**WINIM DEVELOPMENTS
LEVEL 10,
255 GEORGE STREET
SYDNEY NSW 2000**Reference: **1 GATACRE AVE & 5 ALLISON AVE, LANE COVE**

ACCESS REPORT – DEVELOPMENT APPLICATION

RESIDENTIAL DEVELOPMENT 1 GATACRE AVE & 5 ALLISON AVE LANE COVE, NSW 2066

Document Type: Access Report – Development Application

Level 3 Terrace

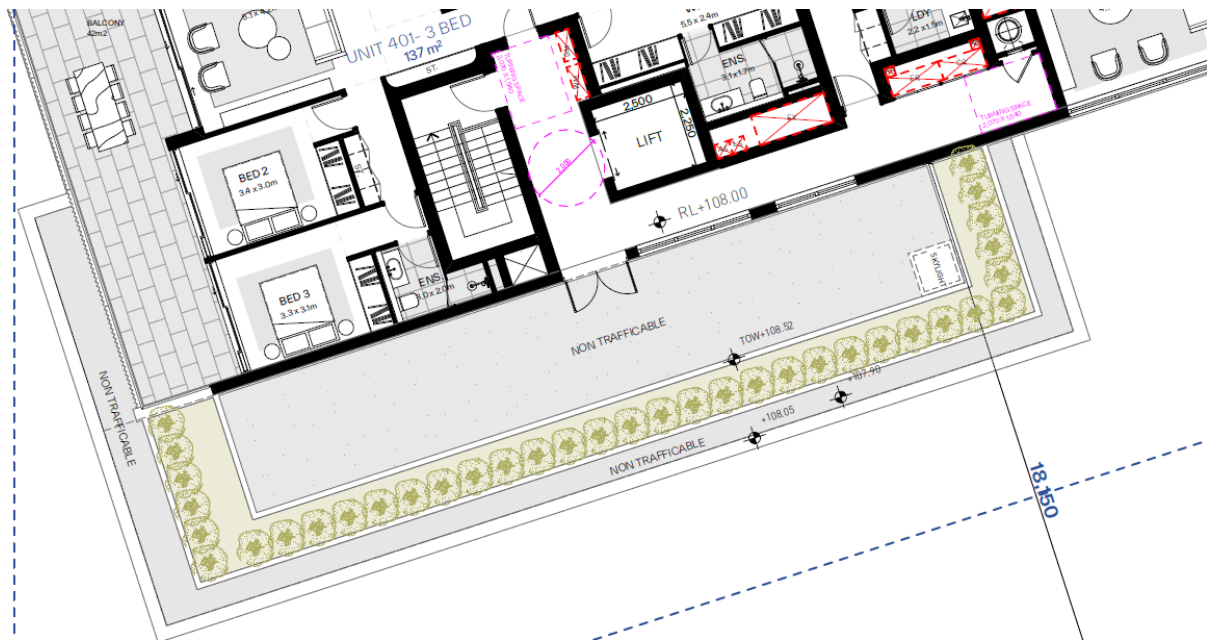
Common garden areas are provided at levels 3 of this development. The features provided at each common terrace area are identical. The common areas are not connected. Lift access enables all residents to access each of the independent terraces. The Level 4 Terrace is non trafficable.

The design proposes non trafficable terraces to Levels 3 & 4.

3.3.7. Wheelchair Passing Spaces

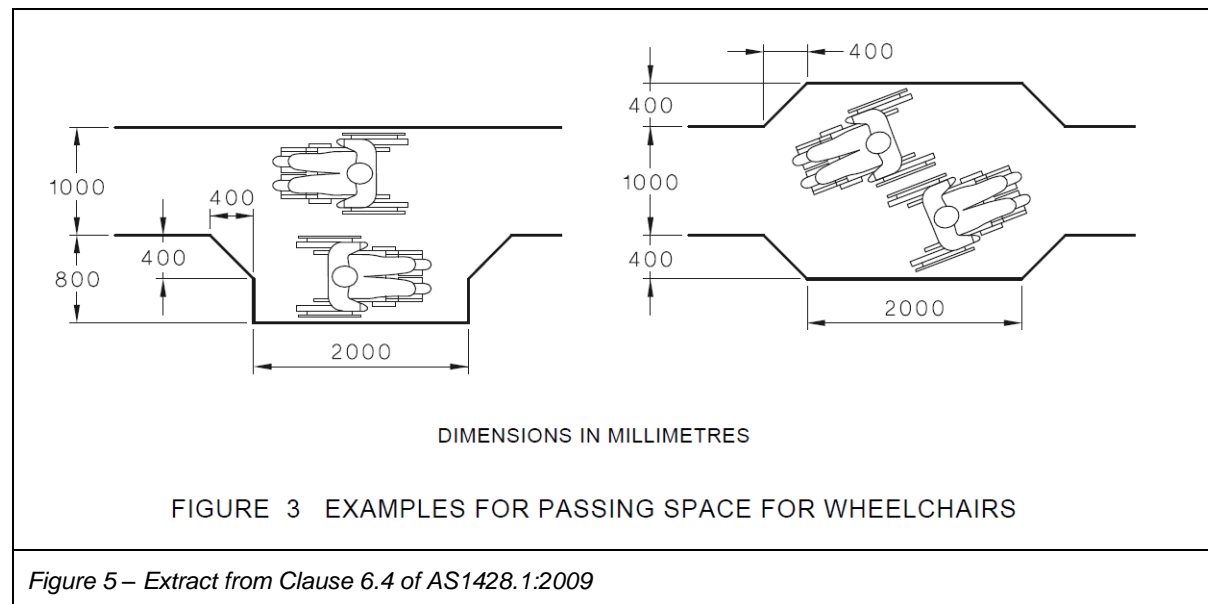
Where the lengths of the Paths of Travel are longer than 20m, an 1800 x 2000mm passing bay is required to be provided in accordance with the provisions of Clause 6.4 of AS1428.1:2009.

The design proposes a pedestrian pathway connecting Gatacre Ave to Allison Ave. The length of this pathway is more than 20m in length. The detailed construction documentation to be prepared for this project is to detail 2000 x 1800mm passing bays along the length of the walkway. The plans presently do not indicate the width of the walkways or the detailing of the walkway profile.

3.3.7. Wheelchair Passing Spaces - The design proposes a pedestrian pathway connecting Gatacre Ave to Allison Ave. The length of this pathway is more than 20m in length. The detailed construction documentation to be prepared for this project is to detail 2000 x 1800mm passing bays along the length of the walkway.
